DISCUSSION

Failure mechanism of the Aznalcóllar Dam, Seville, Spain.

C. OLALLA and V. CUÉLLAR (2001). *Géotechnique* **51**, No. 5, 399–406

Dr A. D. M. Penman, *Chairman ICOLD Committee on Tailings Dams and Waste Lagoons*

Fig. 18. Construction sequence of Aznalcóllar Dam

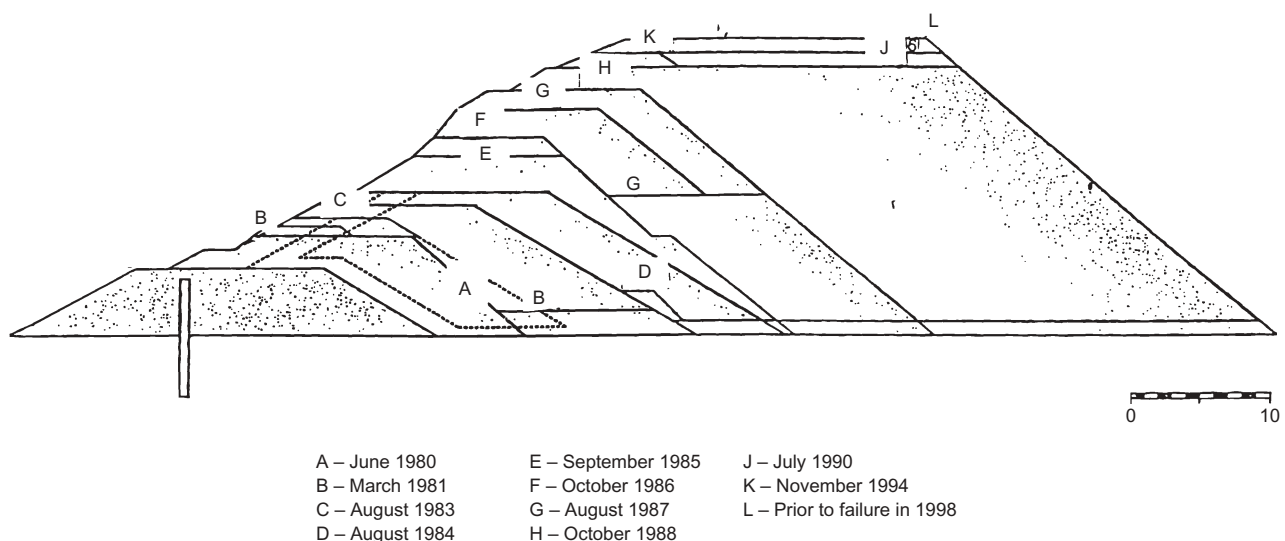
A major difference between embankment dams built to retain water and tailings dams, is their rate of construction. The Aznalcóllar dam was designed to retain water into which tailings were to be placed with a view to keeping the material wet to minimise oxidation and the formation of acid. Had it been built to its full height at one time, it might have looked like the design ideal shown by Fig. 1 of the paper. In fact, in common with most tailings dams, it was constructed in stages, as shown by Fig. 18, over a period of 20 years, raised only to keep pace with the rising level of tailings in the impoundment.

The starter dam and the bentonite-cement diaphragm cut-off wall were constructed at the beginning of the project, and the first part of the sloping impervious core with backup filters and compacted waste rockfill built during the following few years to correct upstream and downstream slopes. Later and up to nearly the end of 1988, construction became more irregular, and it is not clear that the integrity of the impervious core was maintained. A considerable amount of waste rockfill was placed between 1988 and 1990, greatly increasing the width of the dam. During the last eight years prior to failure, the rate of height increase was quite slow.
